MALATA			
Title TRM-602 Wireless AV Tx: Power			
Size B	Document Number		Rev H
Date:	Tuesday, June 20, 2006	Sheet	1 of 3

TF-530 Wireless AV TX rev. H

MALATA			
Title TRM-602 Wireless AV Tx:			
Size Custom	Document Number		Rev H
Date:	Saturday, July 01, 2006	Sheet	1 of 9

MALATA				
Title				
TRM-602 Wireless AV Tx:				
Size B	Document Number			Rev H
Date:	Tuesday, June 20, 2006	Sheet	3	of 3

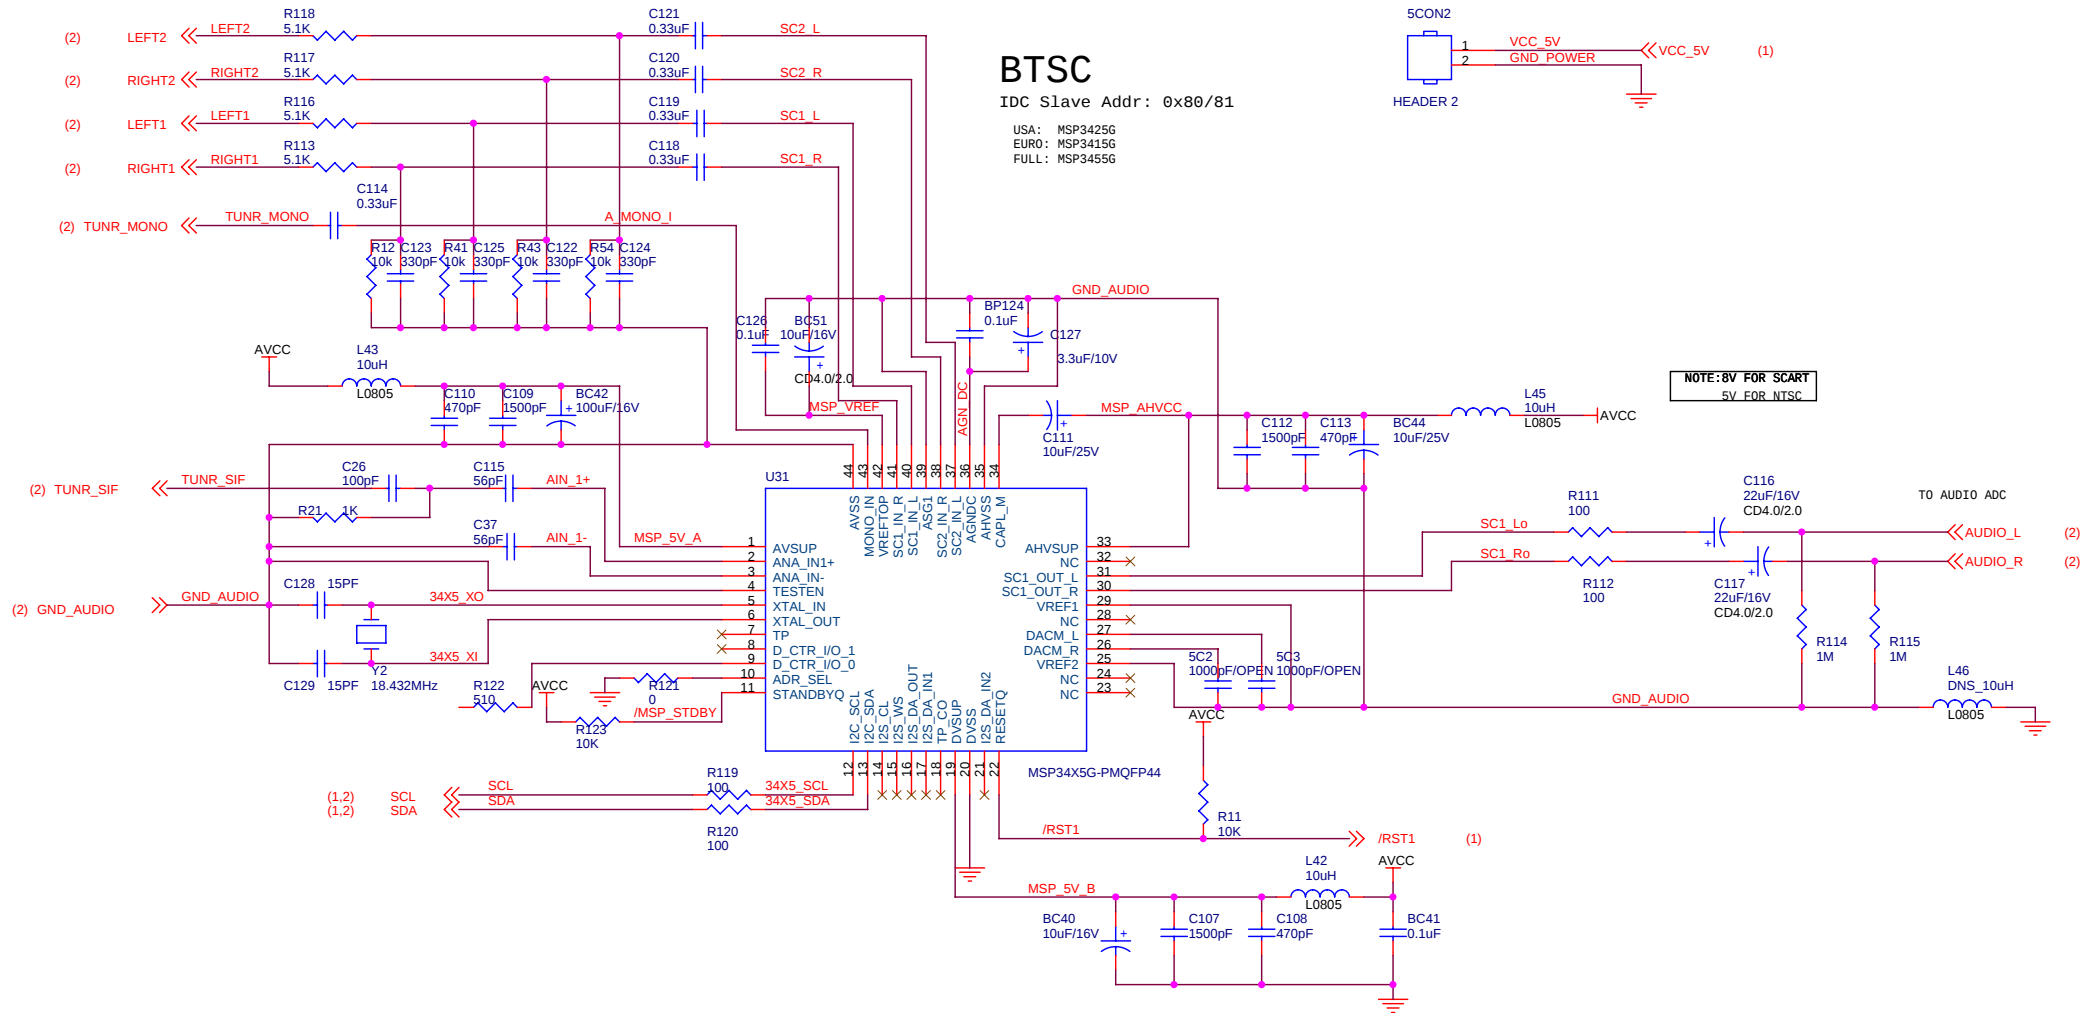
失真问题:1,R118等原为470E改为5.1k
2,添加R12等下拉10k到地;

MALATA		
Title		
TRM-602 Wireless AV Tx:		
Size	Document Number	Rev
B		H
Date:	Saturday, July 01, 2006	Sheet 9 of 9

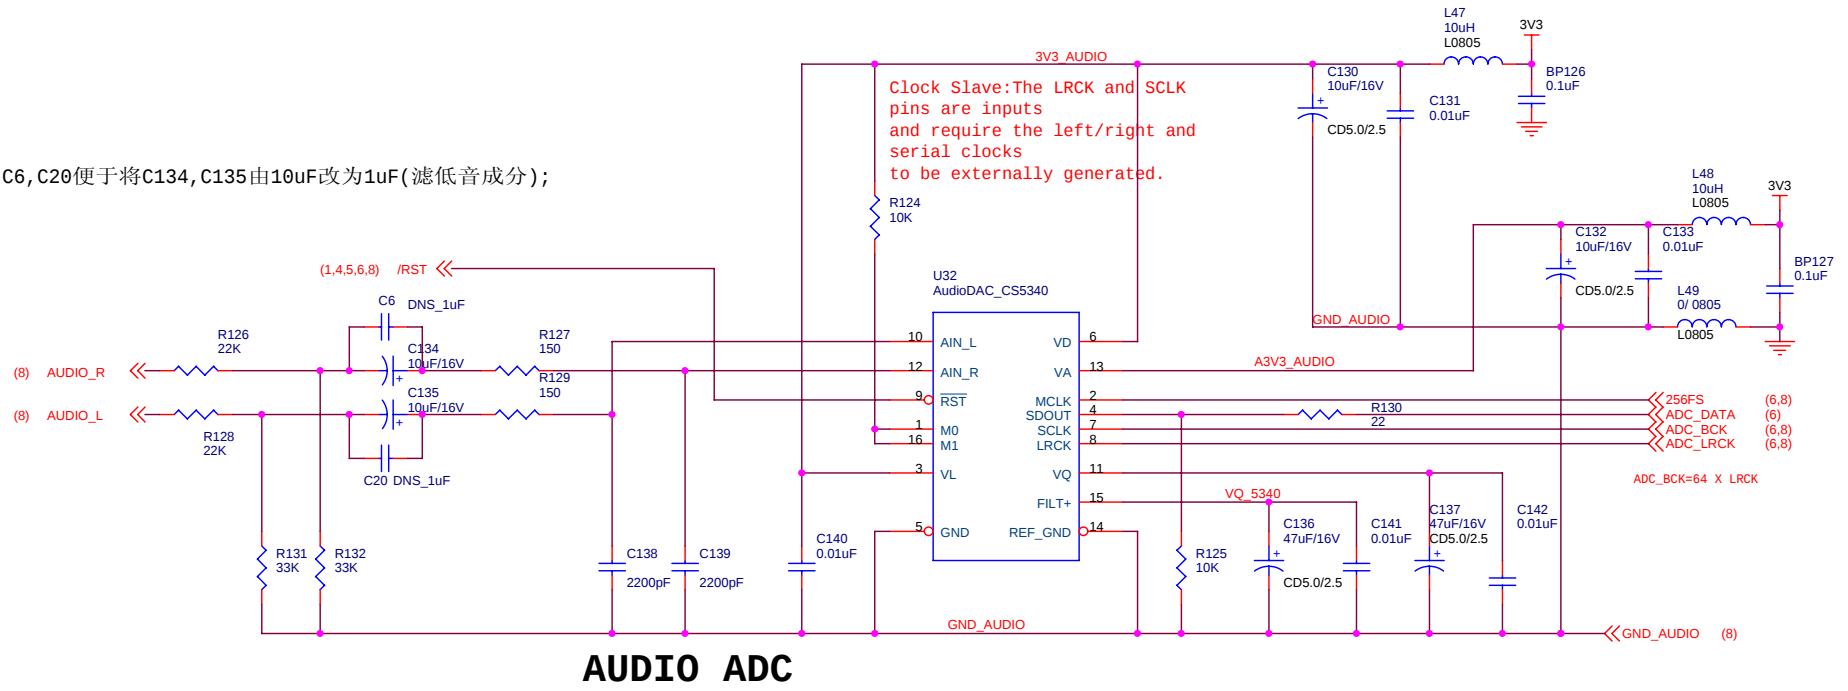
预留C6,C20便于将C134,C135由10uF改为1uF(滤低音成分);
